PERRY NUCLEAR POWER PLANT
10 CENTER RD., PERRY, OHIO 44081

Information Only
New Figure

Information Only
CN=Change

FIGURE 2.4-83

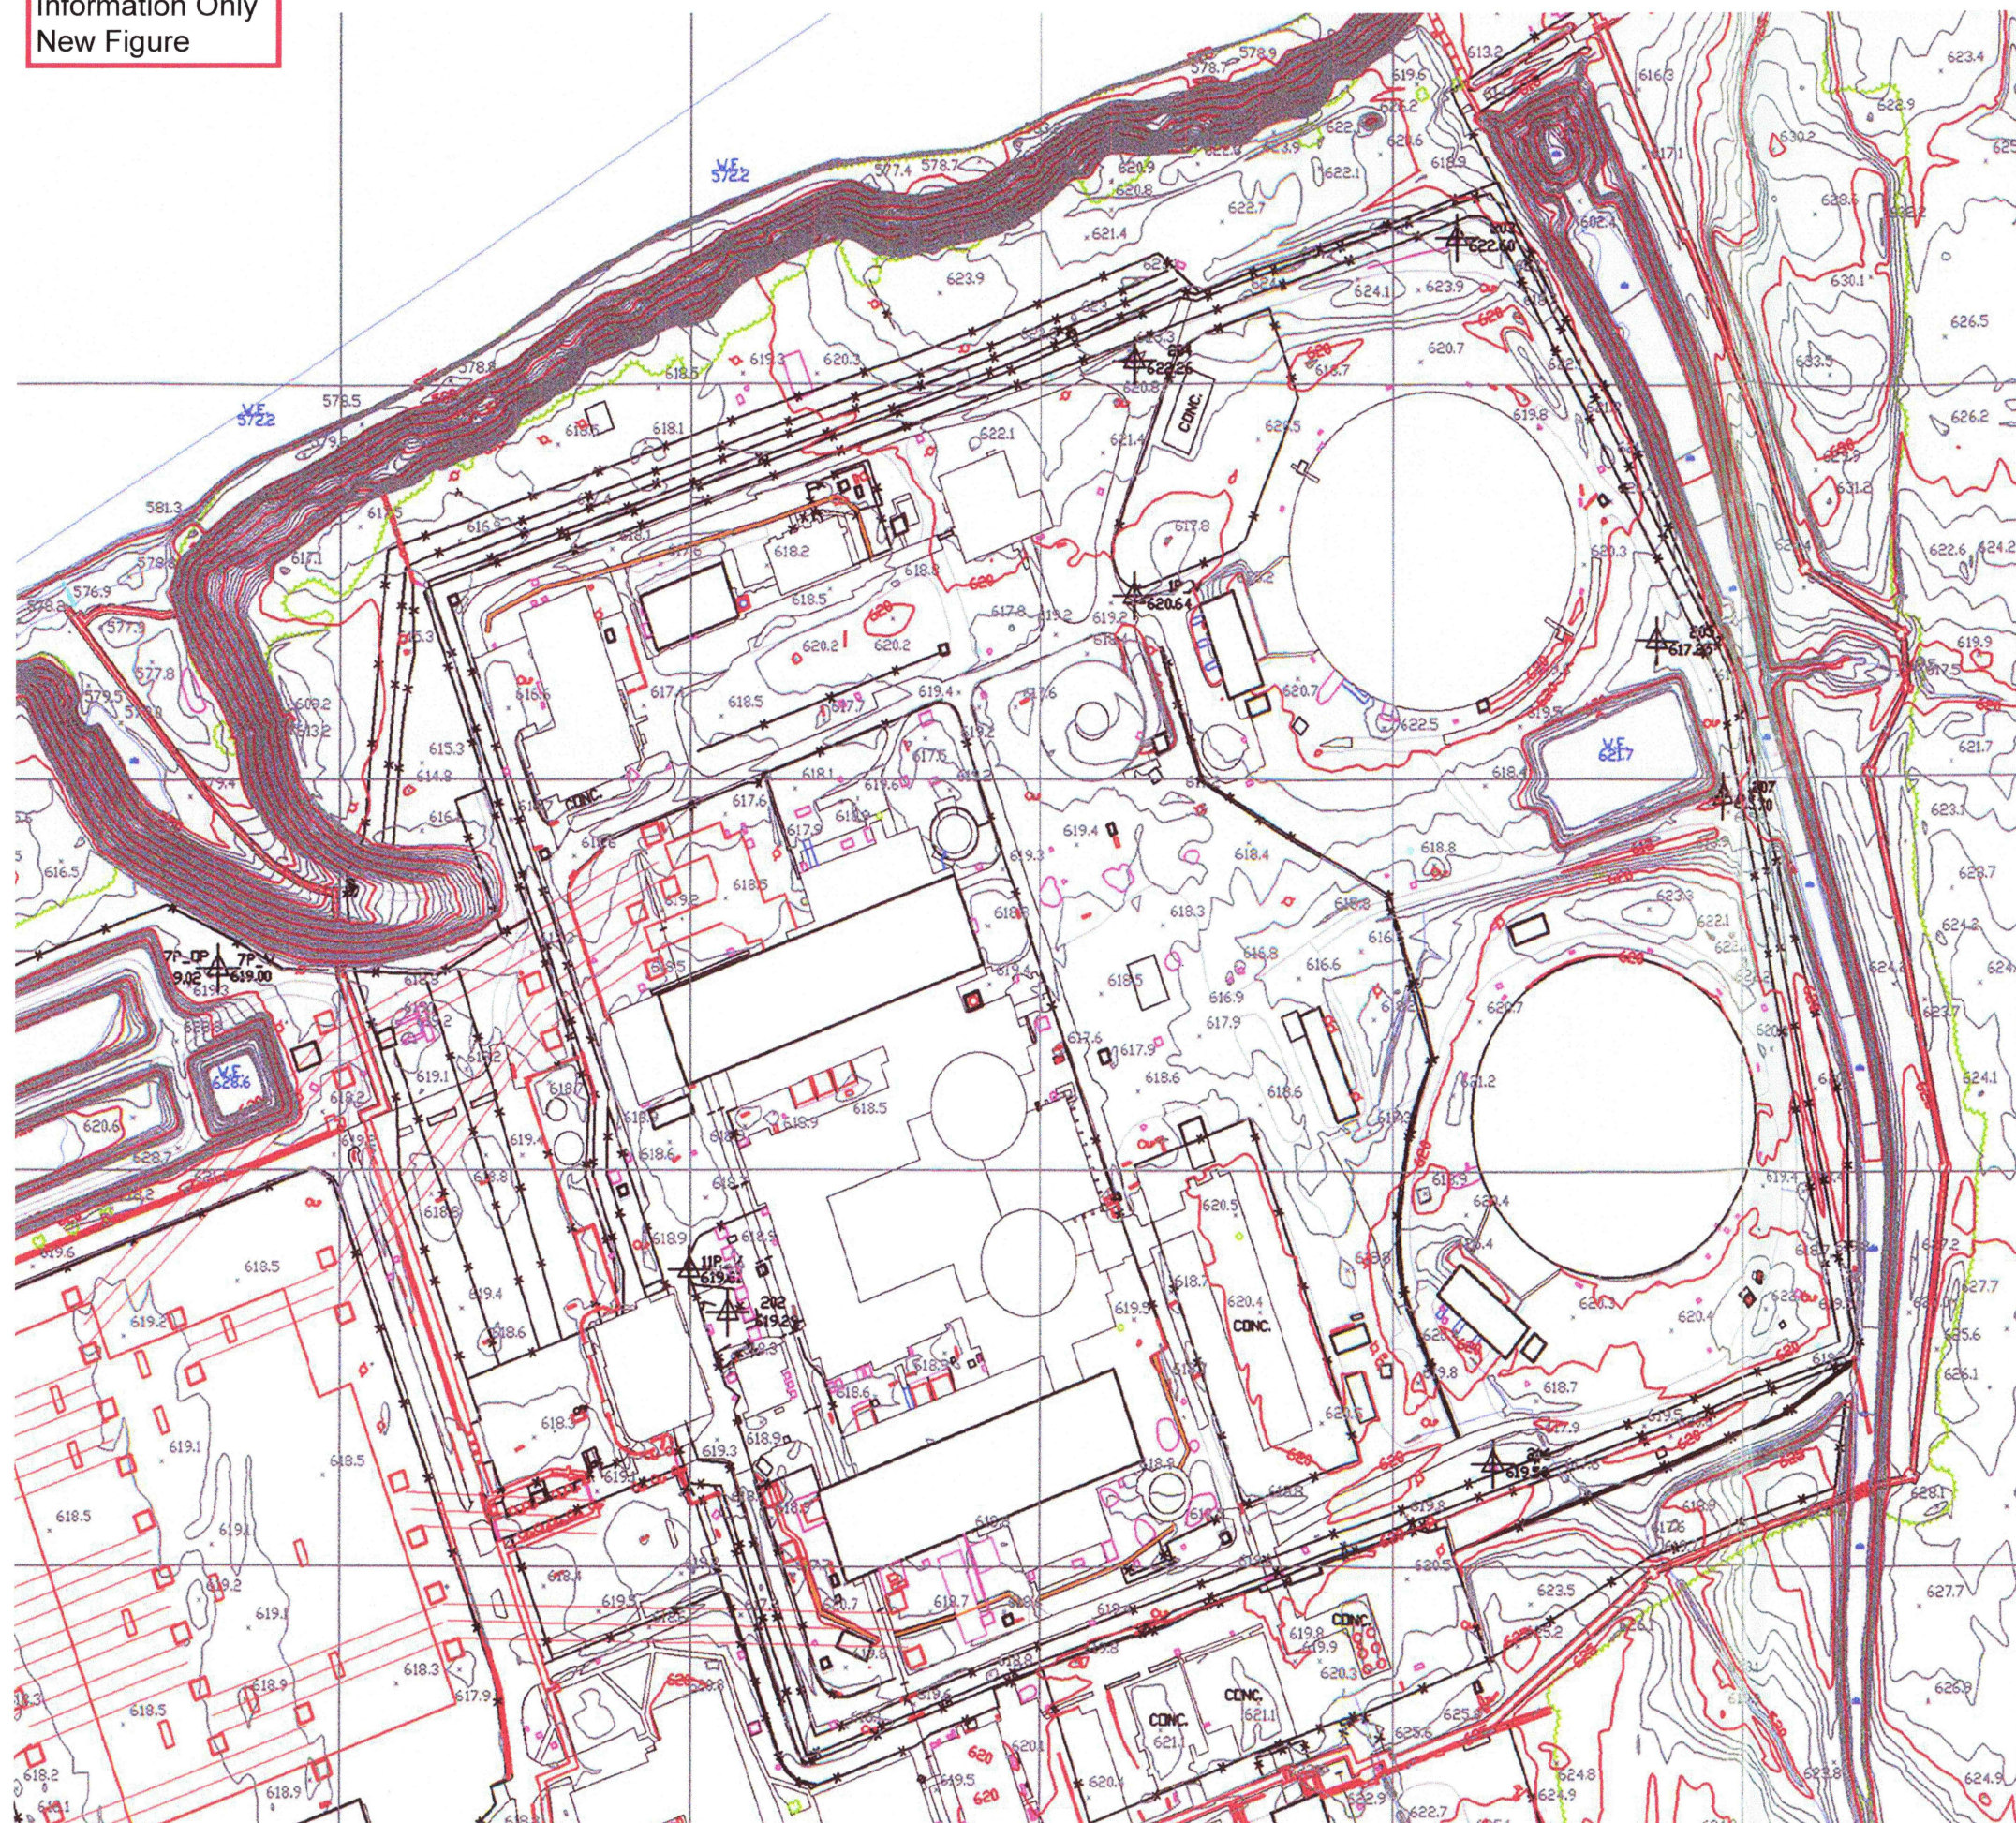
NEW FIGURE

FIGURE 2.4-84

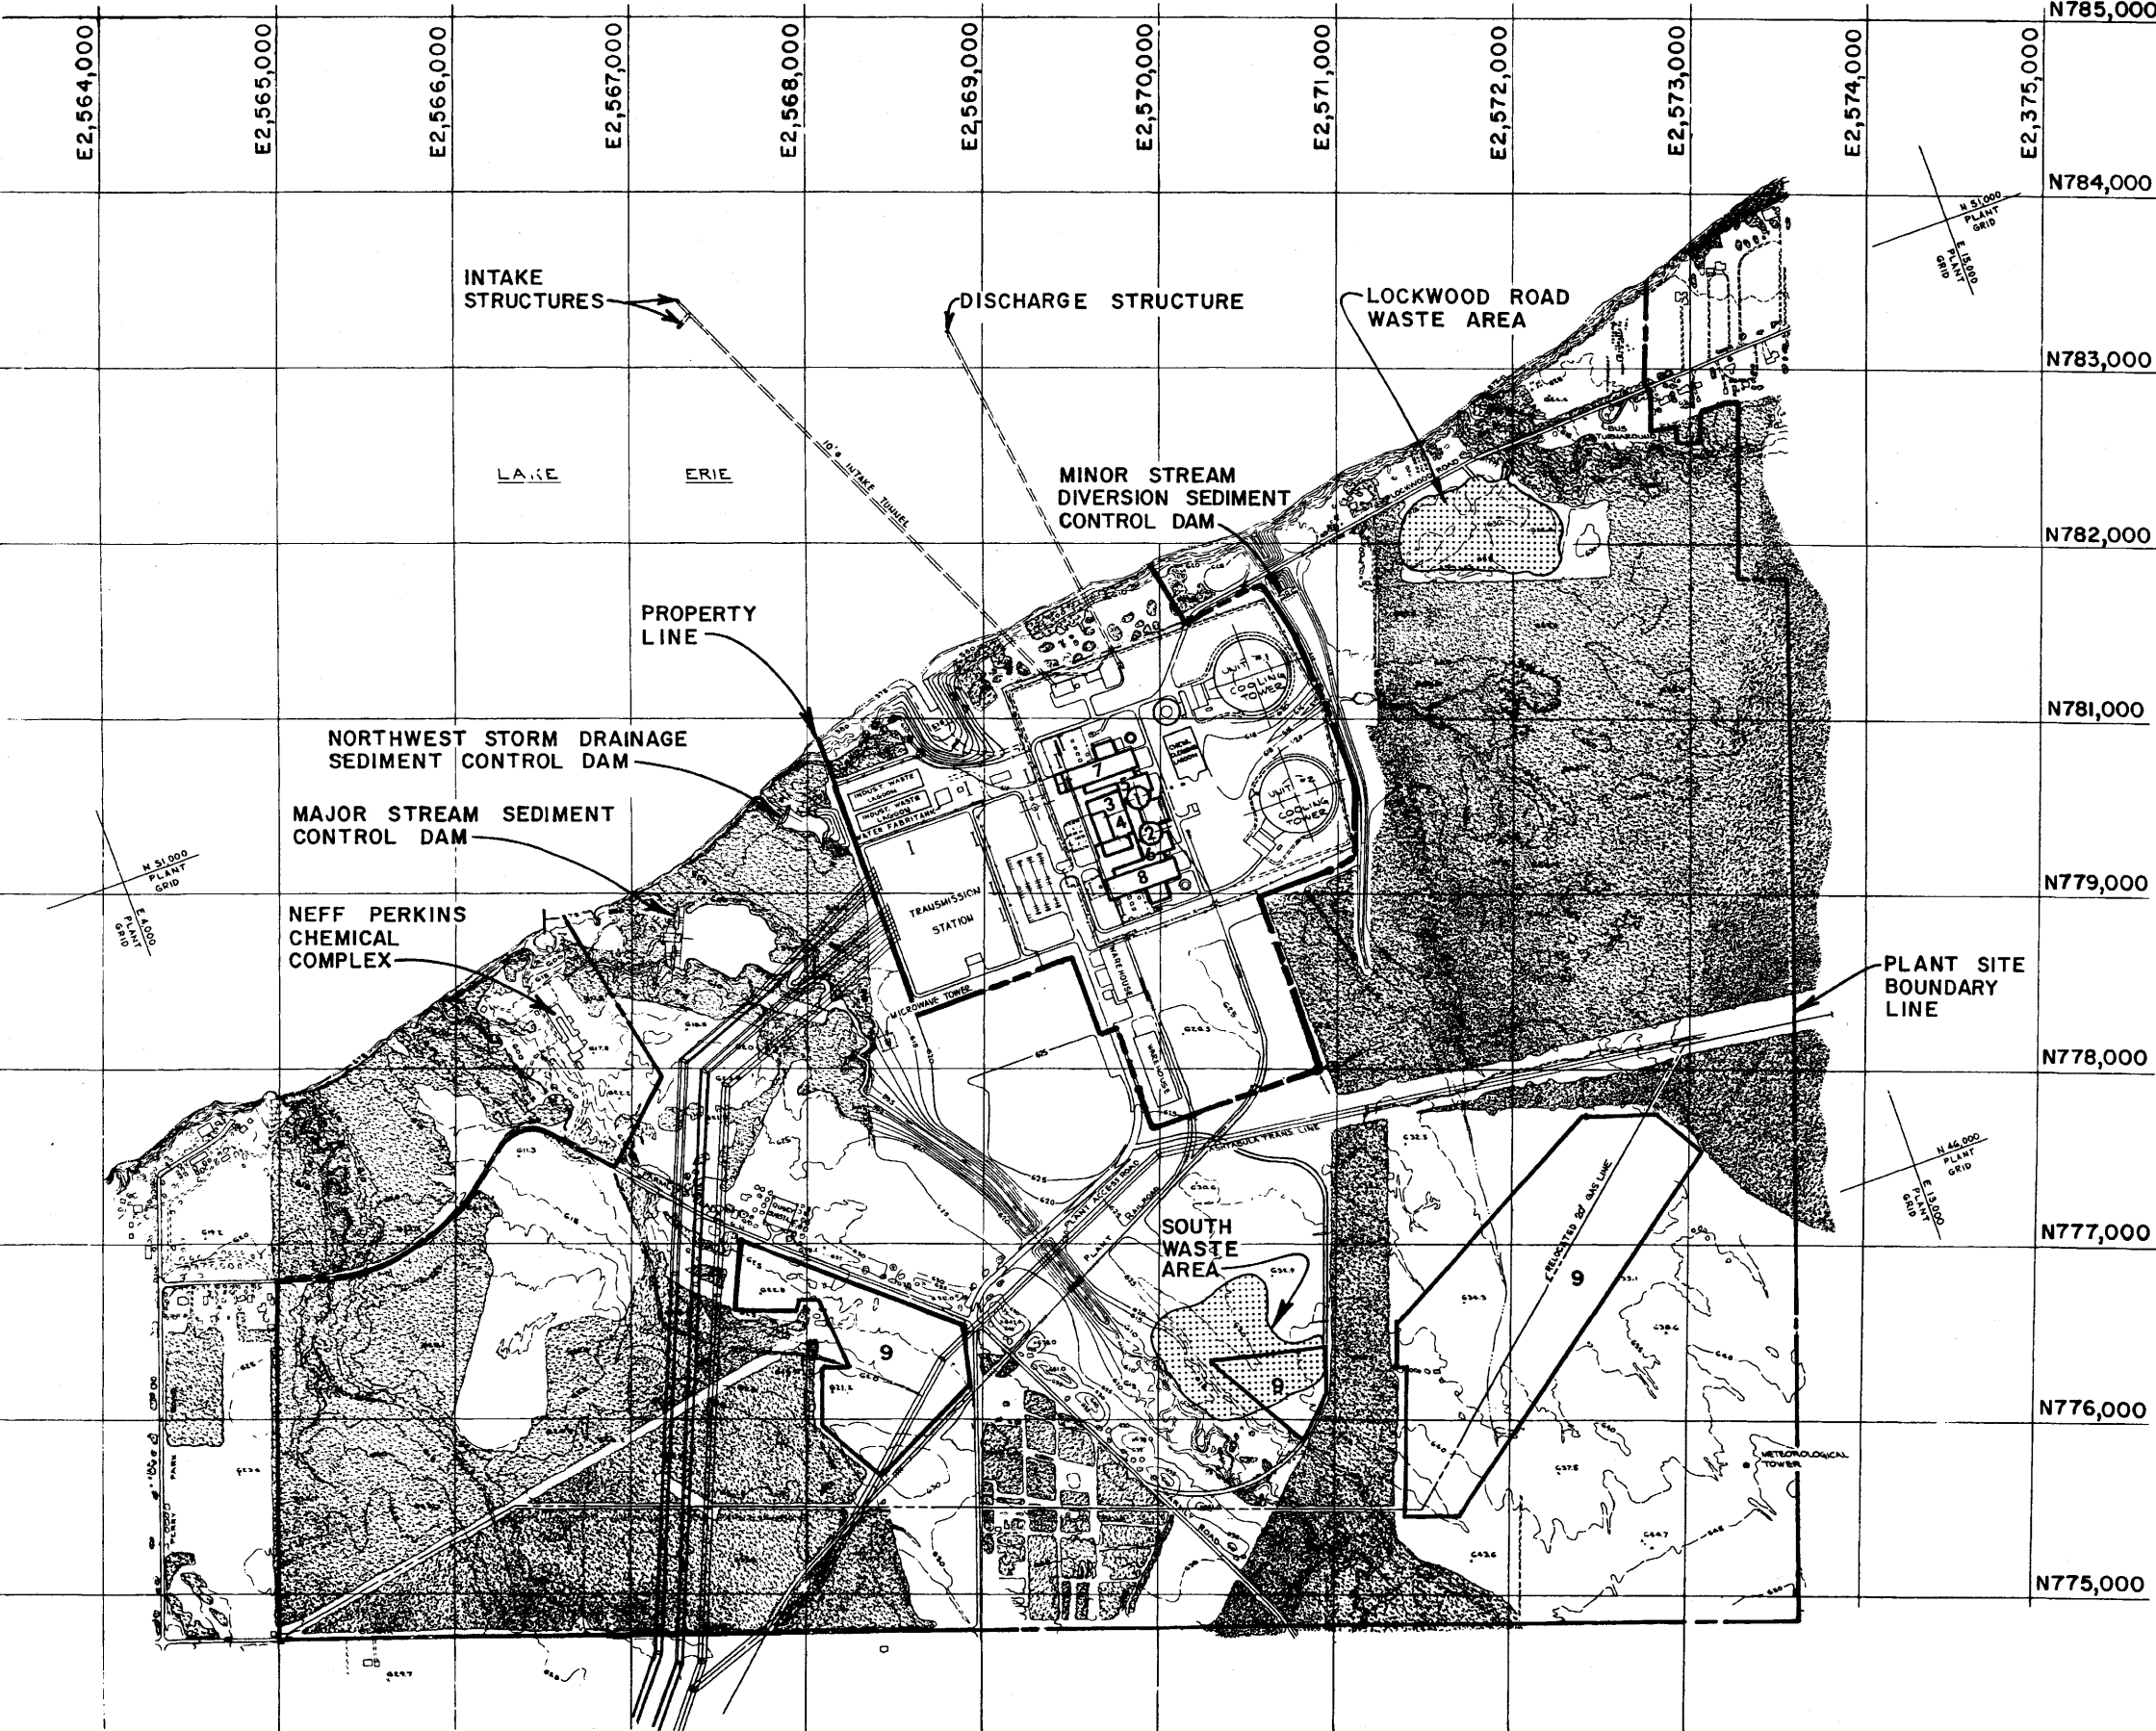
1. SURVEY DATA SHOWN ON THIS FIGURE REFERENCED TO NORTH AMERICAN VERTICAL DATUM OF 1988 (NAVD88)
2. FOR COMPARISON TO PLANT BUILDINGS, CONVERT NAVD88 TO PERRY LOCAL DATUM
3. $\text{NAVD88} + 0.93 \text{ FT} = \text{PLD}$
4. SURVEY DATA SAME AS FIGURE 2.4-83, EXPANDED FOR CLARITY

NEW FIGURE
